## Design Review Subcommittee (DRSC)

Meeting Date: March 23, 2022

**SUBJECT:** **Cultural Heritage Permit 22-008, Casa Rosa Triplex, 100/130 Avenida Rosa**, a request to consider a new, two-story triplex on vacant property located within the Architectural Overlay District.

**Image 2 – Proposed Site Plan**

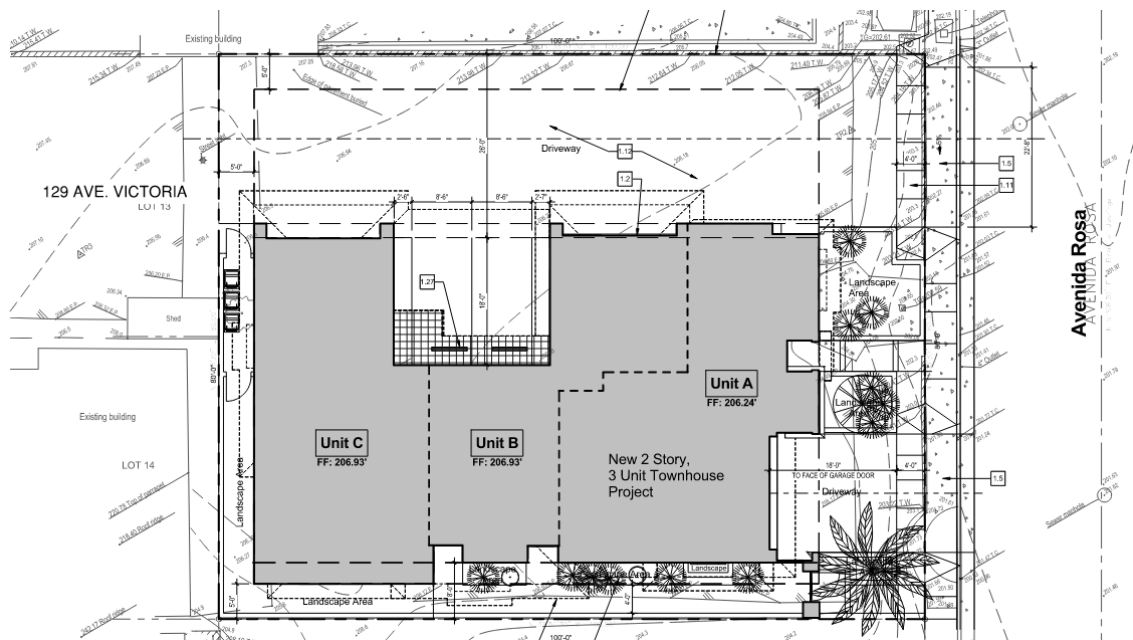
Per CR&R, three trash containers – trash, recycle, and organic - must be provided per residential unit. The project currently provides three trash containers for the entire development. Staff recommends that the applicant contact CR&R to obtain trash container standards for residential sites, and revise the site plan accordingly to accommodate additional trash containers.

1. Provide the height of each chimney on elevation and roof plans, and ensure it does not exceed 27 feet.
2. On the front elevation, provide spacing of exposed rafter tails consistent with the formula provided in the Henry Lenny Design Guidelines.
3. Remove the three free standing metal trellises located in the rear half of the lot to provide sufficient back-up space for vehicles.
4. Revise plans accordingly to provide designated areas for three trash containers per unit, consistent with CR&R standards.
